Re: Response to Loureiro Comments Slate Upper School 5100 Outer Ridge Road North Haven, Connecticut SLR #16156.00003

SLR International Corporation (SLR) is in receipt of a letter from Loureiro dated January 25, 2021, regarding the above-referenced project. We offer the following responses to its comments:

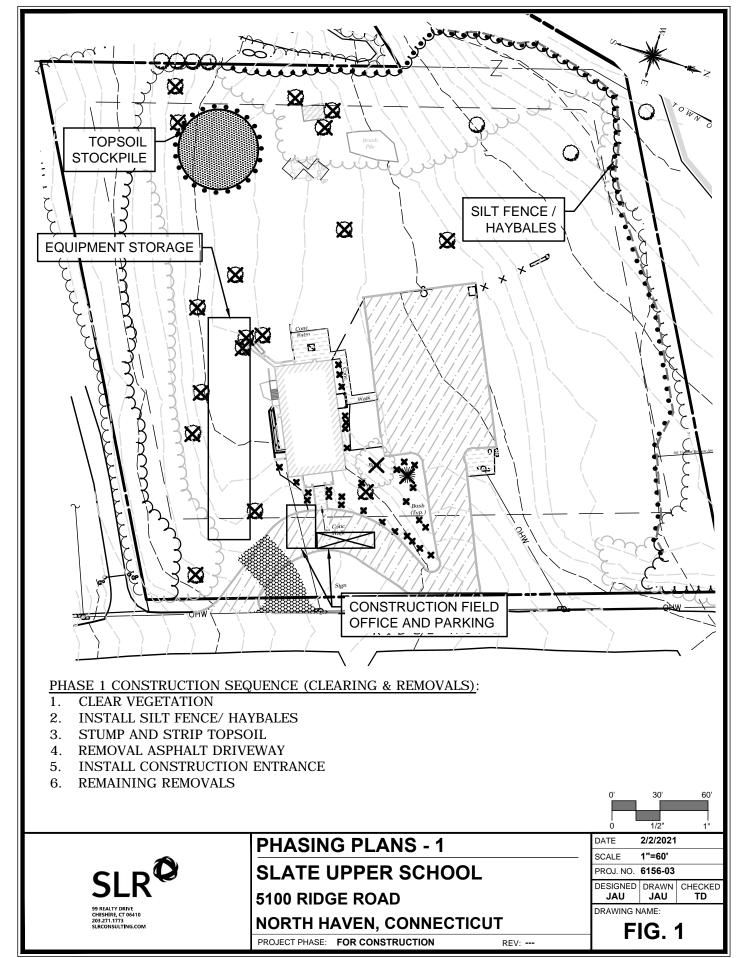
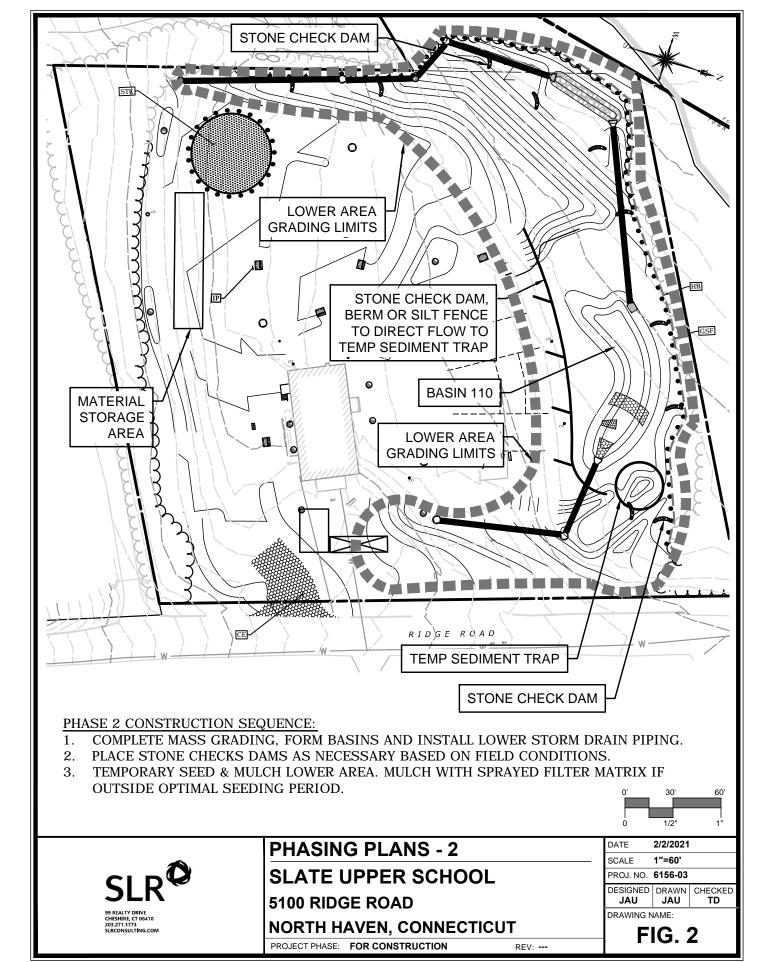
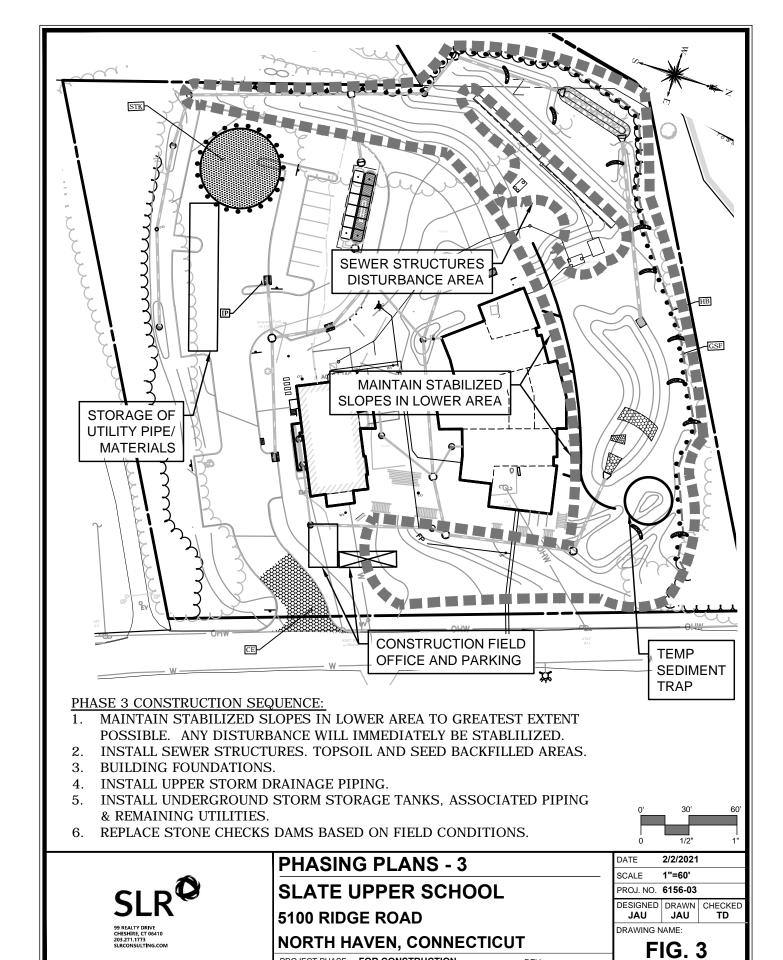
All construction activities have been protected with erosion controls. Enclosed is a detailed phasing plan to show how the project will be developed. These plans show that at no time will the entire area be disturbed. The proposed erosion control plan has been designed to mitigate any temporary construction activities.
